SALISBURY PARK NORTH PHASE 1

TOWN OF PARKER

SITE PLAN

SITE PLAN SUBMITTAL
Page 1 of 311

COVER SHEET

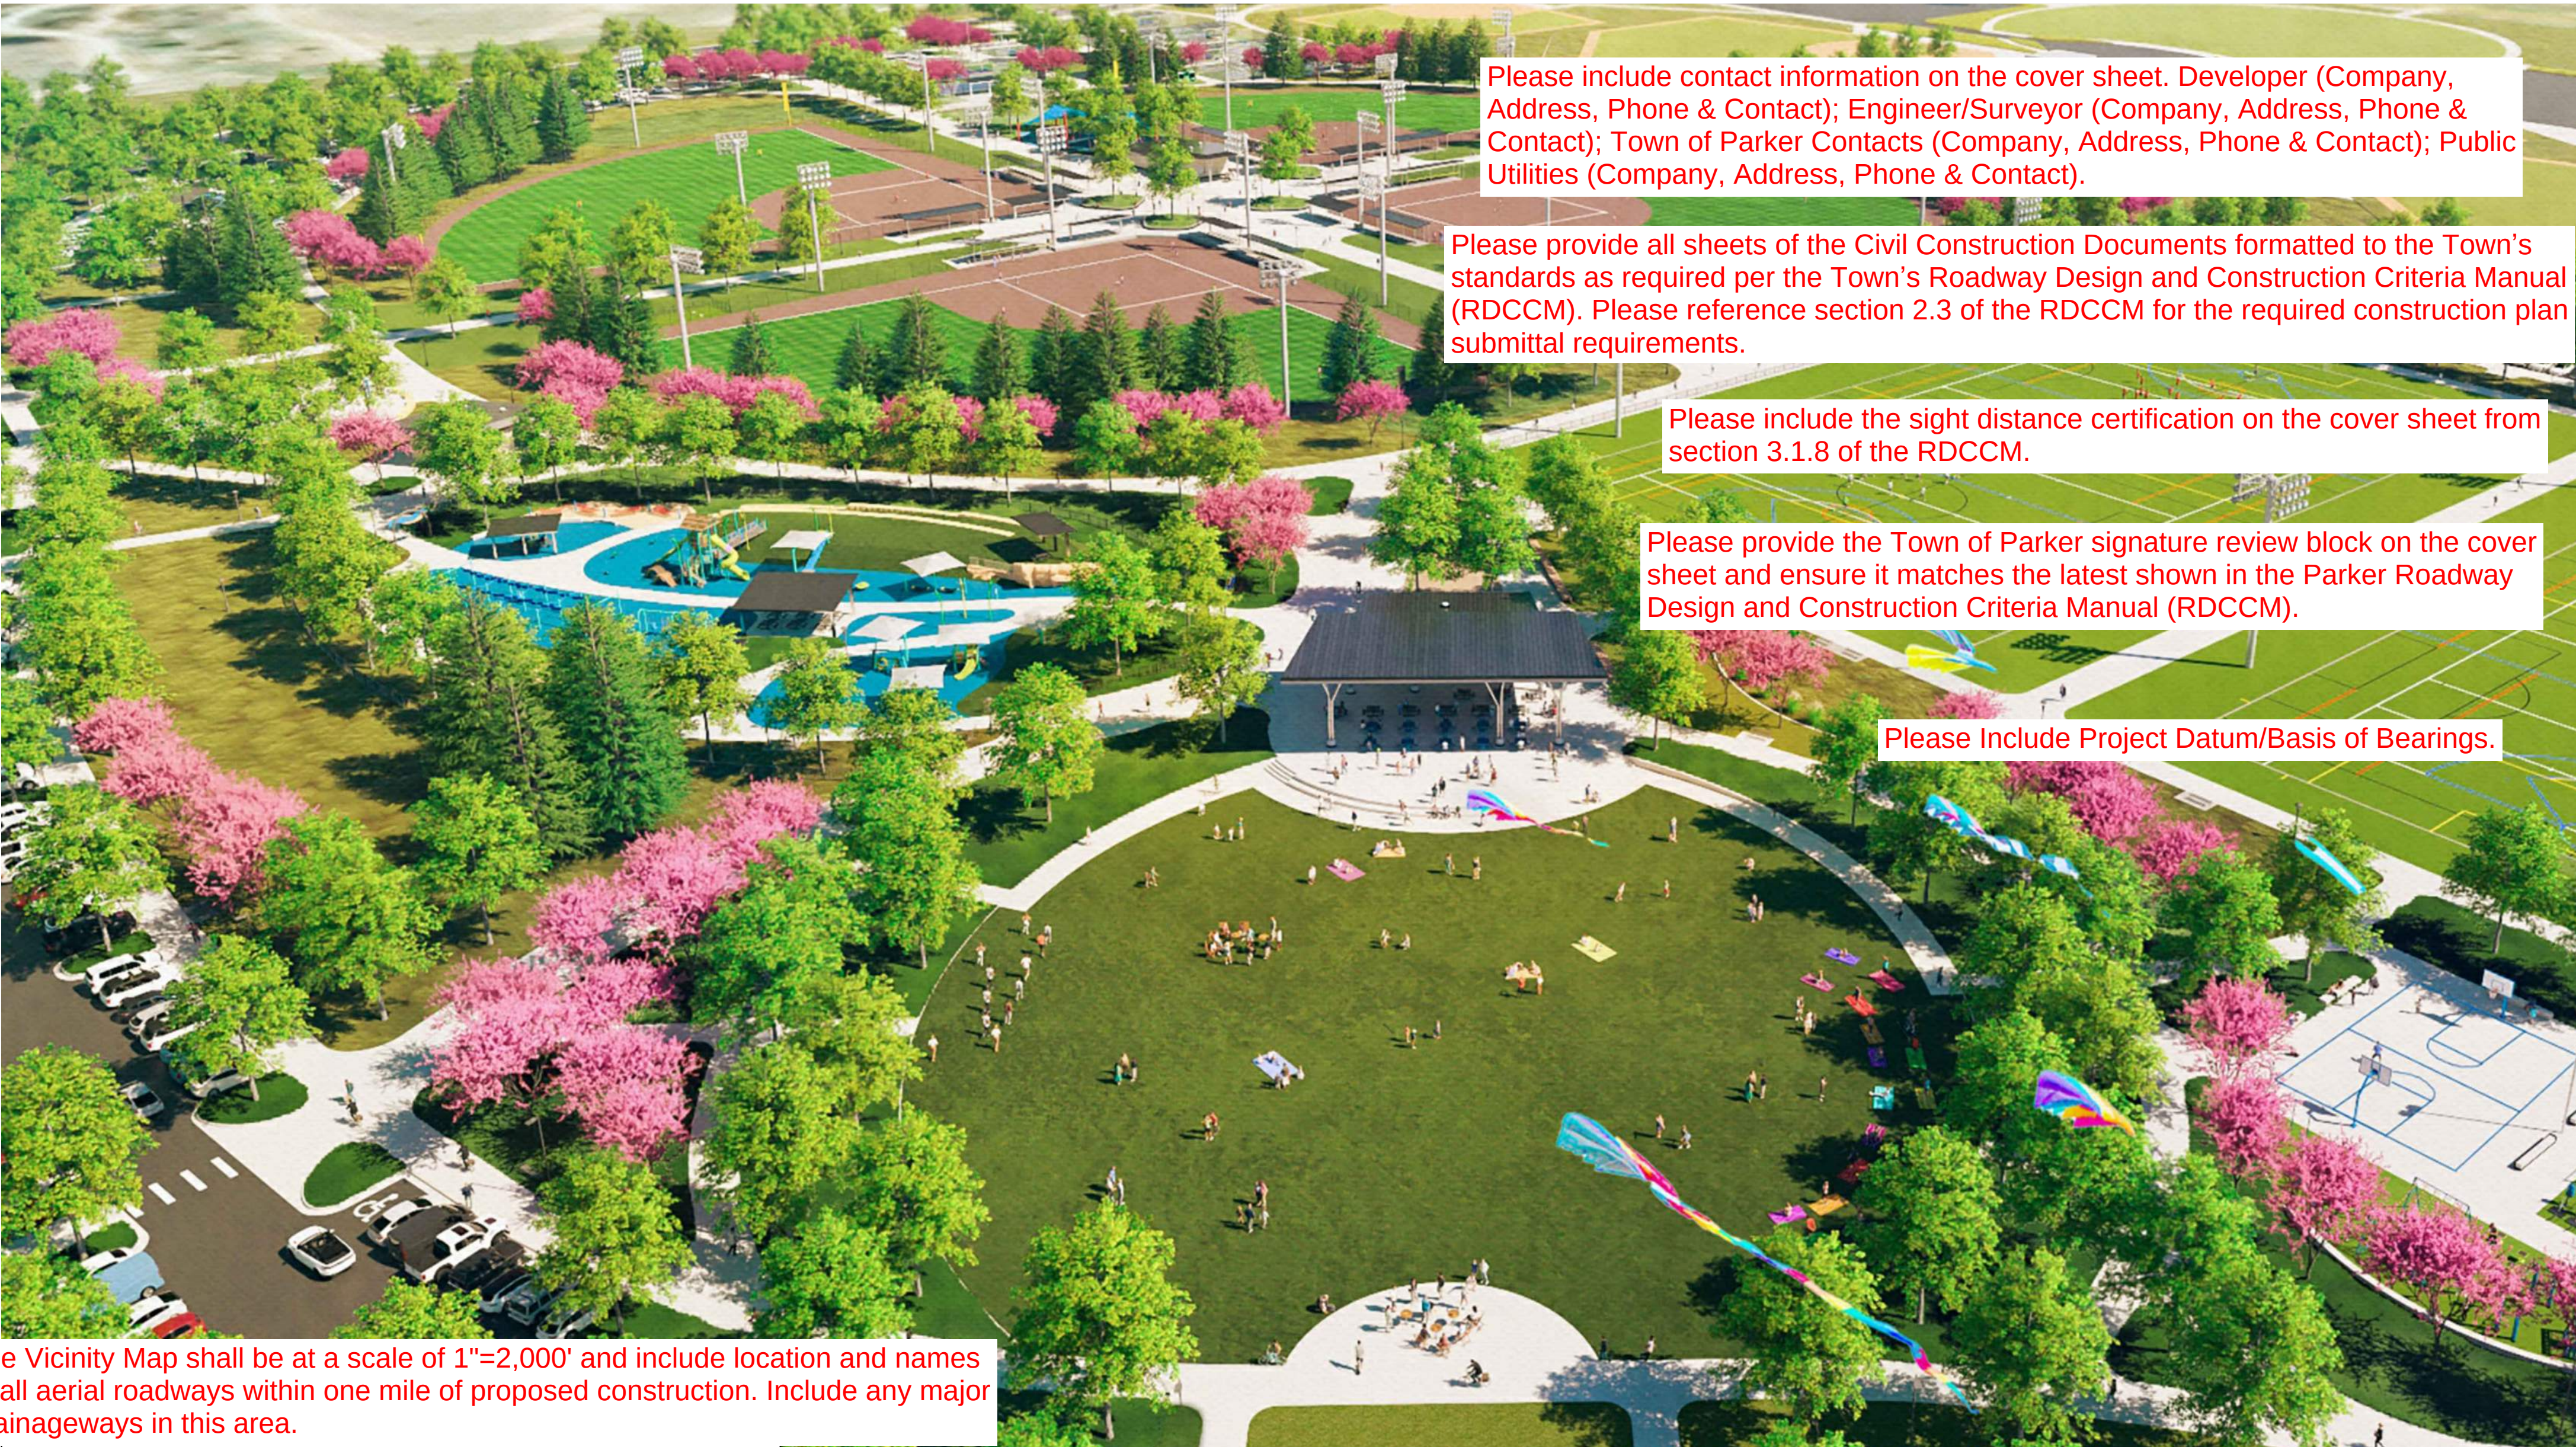
Please include contact information on the cover sheet. Developer (Company, Address, Phone & Contact); Engineer/Surveyor (Company, Address, Phone & Contact); Town of Parker Contacts (Company, Address, Phone & Contact); Public Utilities (Company, Address, Phone & Contact).

Please provide all sheets of the Civil Construction Documents formatted to the Town's standards as required per the Town's Roadway Design and Construction Criteria Manual (RDCCM). Please reference section 2.3 of the RDCCM for the required construction plan submittal requirements.

Please include the sight distance certification on the cover sheet from section 3.1.8 of the RDCCM.

Please provide the Town of Parker signature review block on the cover sheet and ensure it matches the latest shown in the Parker Roadway Design and Construction Criteria Manual (RDCCM).

Please Include Project Datum/Basis of Bearings.

The Vicinity Map shall be at a scale of 1"=2,000' and include location and names of all aerial roadways within one mile of proposed construction. Include any major drainageways in this area.

Drawing
**OVERALL GRADING &
DRAINAGE PLAN (FINAL)**

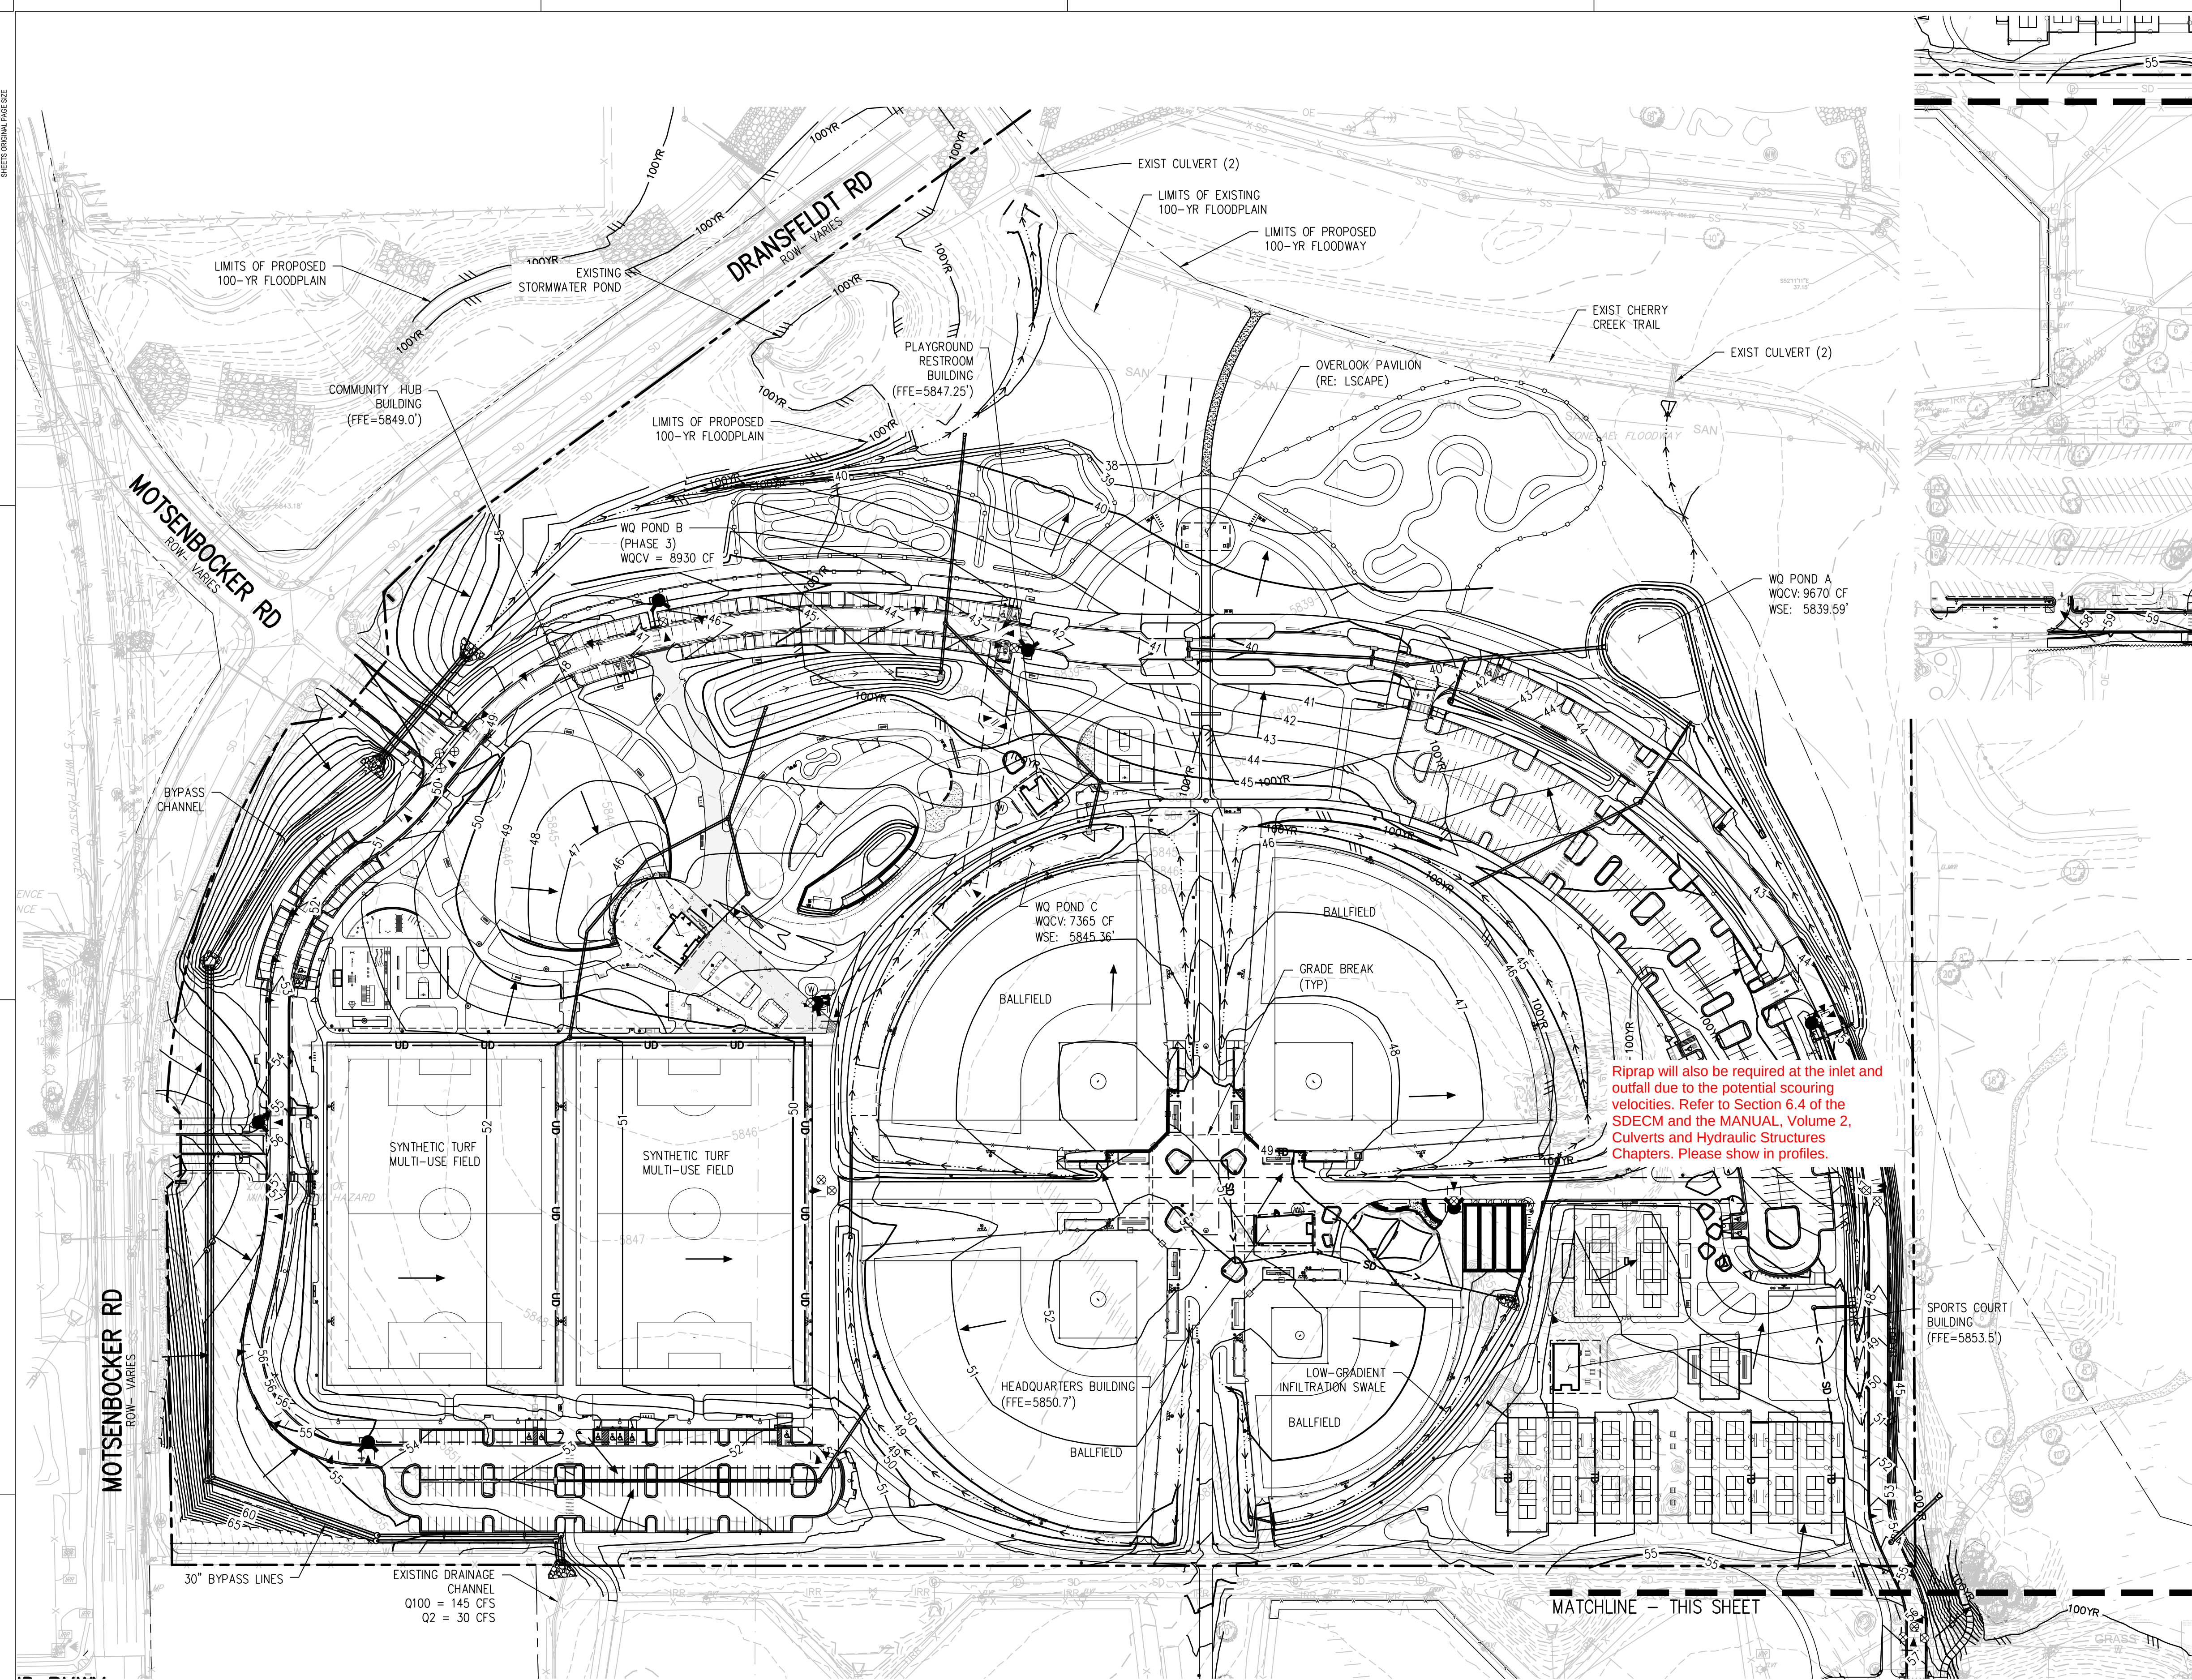
Riprap will also be required at the inlet and outfall due to the potential scouring velocities. Refer to Section 6.4 of the SDECM and the MANUAL, Volume 2, Culverts and Hydraulic Structures Chapters. Please show in profiles.
